APPLICATION NO.	FILING DATE	FIRST NAMED INVENTOR	ATTORNEY DOCKET NO.	CONFIRMATION NO.
09/476,521	01/03/2000	Herbert Gropp	RUM212	7964

LUONG, VINH

Office Action Summary

Fig. 1

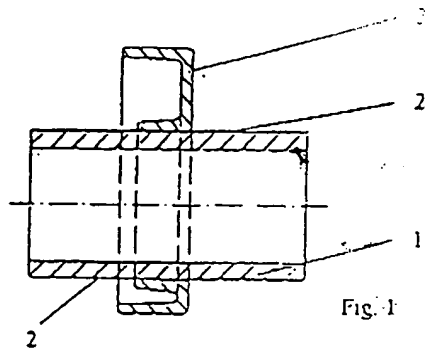
(a) the drawings should show the plane upon which a sectional view such as Fig. 1 is taken; and

Fig. 3

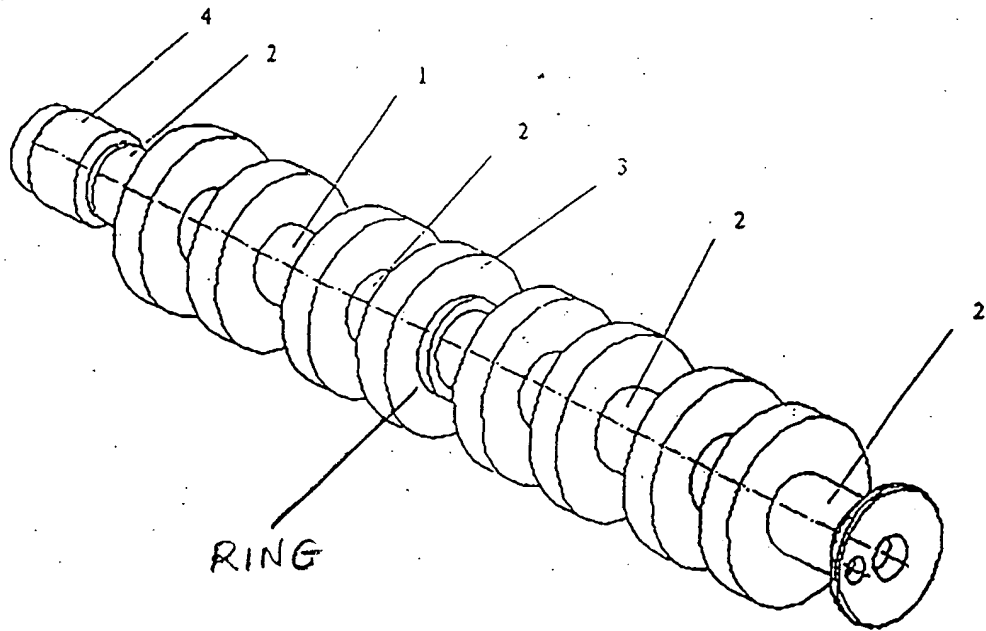
- (b) new Fig. 3 introduces new matter, such as, the deletion of a ring (unnumbered, see Exhibit attached). The original Fig. 3 shows the ring located adjacent to the cam 3, however, new Fig. 3 now does not show such ring. See *Twin Disc v. United States*, 231 USPQ 417, 435 (US Cls. Ct. 1986)(new matter by deletion).
